RFI Transmittal

PROJECT: CUNY New Academic Building DATE SENT: 1/23/2017
CUN-901

SUBJECT: 1130 - Design Movement between the Auditorium and Main Building RFI ID: 1130

Drawing Title:	
DETAIL OF CURTAIN WALL	
Drawing No.	020
Scale	5/8"=1'-0"
Designed By	Date
Yongye	MAY 20/2014
Checked By	Date
Makeng	MAY 21/2014
Approved By	Date
Zhangyong's	MAY 20/2014

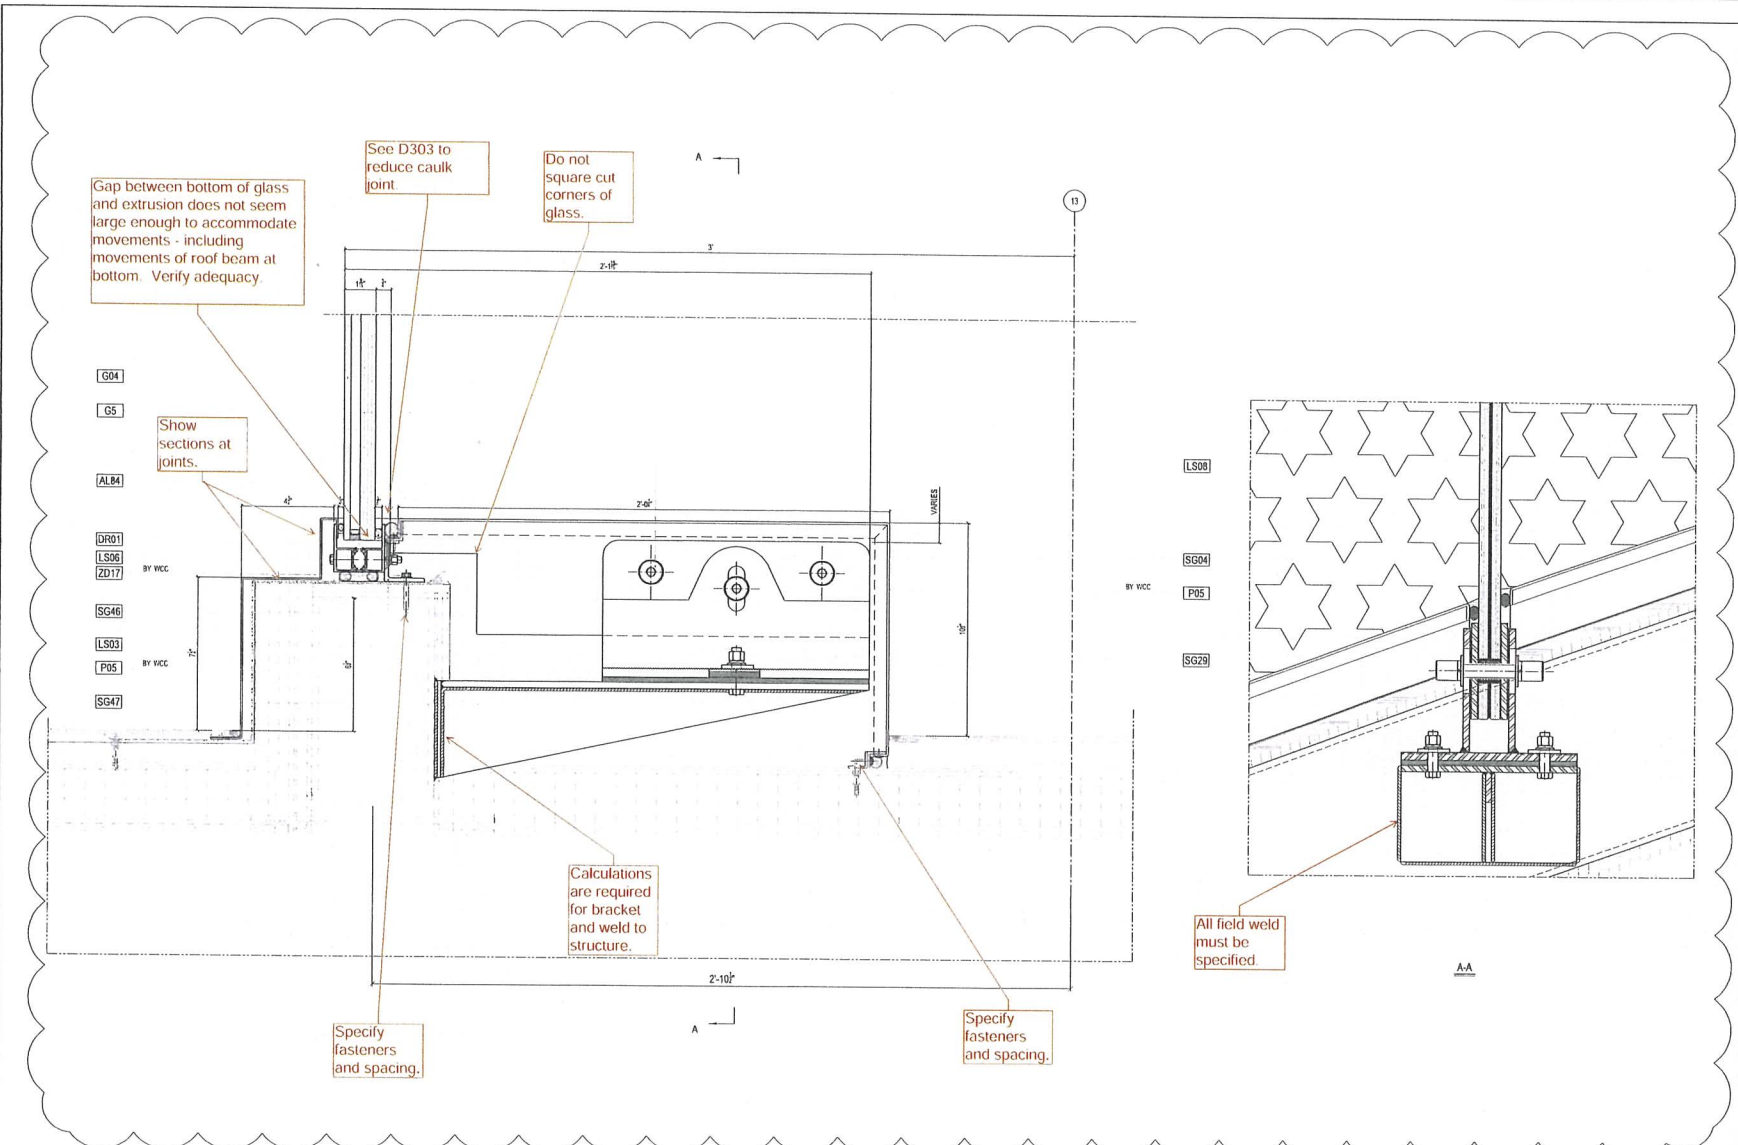
QUESTION: In reviewing submittal 084426-007-01 the Design Team included a comment that "The structural adequacy of this anchor and the relative movements between auditorium roof and main building still has not been submitted." Please define what the relative movement between the auditorium roof and main building is per design so that Whitestone can provide Yuanda with that information for analysis to ensure that the design movement was adequately addressed in the facade design.

1. SHOP DWG SUBMISSION NUMBERS MUST BE IN SEQUENCE OF THE PREVIOUS SUBMISSIONS.
2. THE CONCERN WAS PREVIOUSLY NOTED IN 2014 UNDER SUBMITTALS 084413-020-01 AND 084413-020-02 ON SHEETS D328, D329, D331 AND Y52 TO VERIFY A LARGER MOVEMENT JOINT TO ACCOMODATE ROOF DEFLECTIONS. THE NOTE WAS ALSO INDICATED ON RFIS 1033 AND 1033R1.
3. REFER TO ATTACHED ESTIMATED ROOF DEFLECTIONS BY WSP. NOTE: WSP CLARIFIED 50% OF THE SDL HAS ALREADY OCCURRED AND THAT FIGURE CAN BE REDUCED. EVEN WITH THE 50% REDUCTION OF THE SDL DEFLECTION, WE BELIEVE THE CONTRACTOR'S HEAD ANCHOR DETAIL MAY NOT ACCOMODATE THE ESTIMATED ROOF DEFLECTIONS.
4. REFER TO ASK- 266 FOR SUGGESTION FOR THE HEAD ANCHOR DETAIL TO ACCOMODATE POTENTIAL MOVEMENT.
